**Service Bulletin: LAT-160F (serial numbers 2013-2015)**

**Date of issue:** 6<sup>th</sup> June 2019

*Figure 3:* Pear shape washer location at lower end of compensating link.

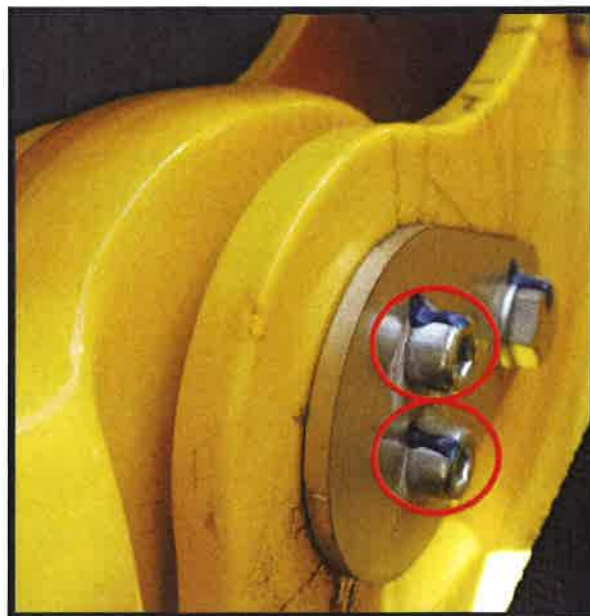
During operation of the lift please check that both retaining plates do not rotate and that there is no excessive play/ movement in the two bolts securing the pear shape retaining plate shown below in *Figure 3*.

Versalift have taken these precautionary measures to reduce any potential risk to its customers and their operators. Due to the critical functionality of this component Versalift ask that this in-service inspection be carried out immediately upon receipt of this bulletin. If any wear or damage is visible, then please remove the vehicle from use and contact the After Sales team.
